RS-03-064

Braidwood Station, Units 1 and 2
Facility Operating License Nos. NPF-72 and NPF-77
NRC Docket Nos. STN 50-456 and STN 50-457

Byron Station, Units 1 and 2
Facility Operating License Nos. NPF-37 and NPF-66
NRC Docket Nos. STN 50-454 and STN 50-455

Subject: Request for a License Amendment to Revise the Pressurizer Safety Valves Lift Settings

Figure 1

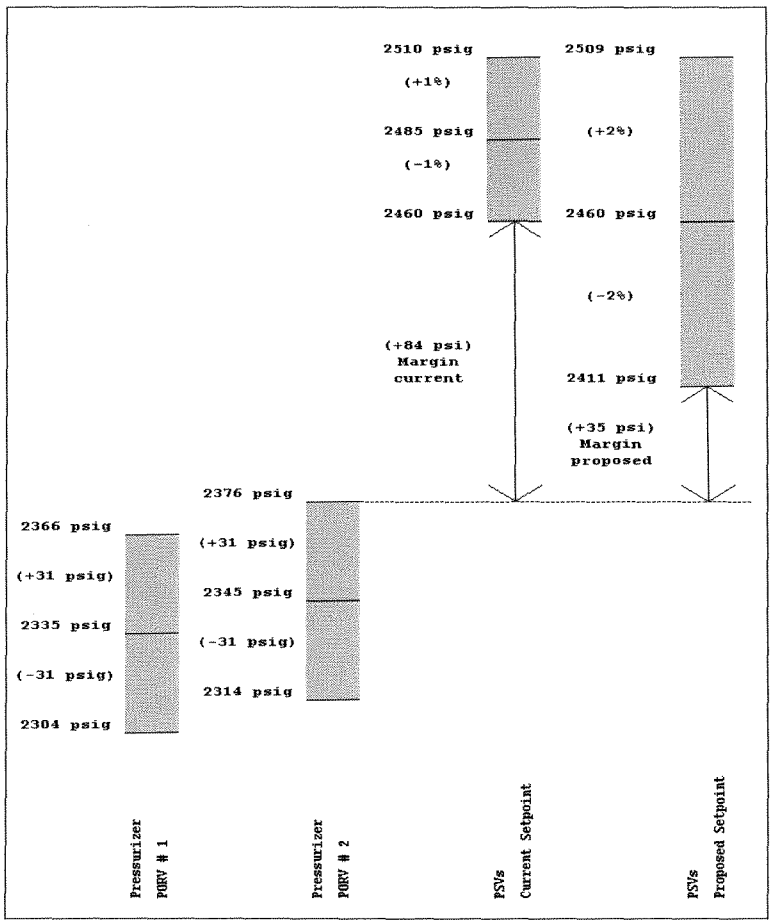
challenges to the PSVs. The impact of the proposed change on the adequacy of margin between the opening of the pressurizer PORVs and the opening of the PSVs was evaluated. The pressurizer PORVs are designed to lift prior to the PSVs. At Braidwood, the two pressurizer PORVs have staggered setpoints of 2335 psig and 2345 psig. The calculated uncertainty associated with opening the pressurizer PORVs was determined to be ±31 psig based on a recent design change that removed the compensated pressure signal from one of the pressurizer PORVs. That is, currently at Braidwood, both pressurizer PORVs receive input from uncompensated pressure signals. Conservatively applying the pressurizer PORV instrument uncertainty (i.e., ±31 psig) to the nominal actuation setpoint of the pressurizer PORV with the highest setpoint (i.e., 2345 psig), results in an actuation band between 2314 and 2376 psig. When compared to the current PSV lift setpoint and associated setpoint tolerance (i.e., 2485 psig ±1% resulting in an actuation band of 2460 and 2510 psig), the margin between the highest possible actuation of a pressurizer PORV (i.e., 2376 psig) and the lowest possible actuation of a PSV (i.e. 2460 psig) is 84 psi. When compared to the proposed PSV lift setpoint and associated setpoint tolerance (i.e., 2460 psig ±2% resulting in an actuation band of 2411 and 2509 psig), the margin between the highest possible actuation of a pressurizer PORV (i.e., 2376 psig) and the lowest possible actuation of a PSV (i.e. 2411 psig) is 35 psi. Refer to Figure 1 below.

Although the proposed change results in a reduction in the margin between opening the pressurizer PORVs and opening the PSVs, the resulting margin is still sufficient to ensure that the PORVs will actuate prior to the PSVs.
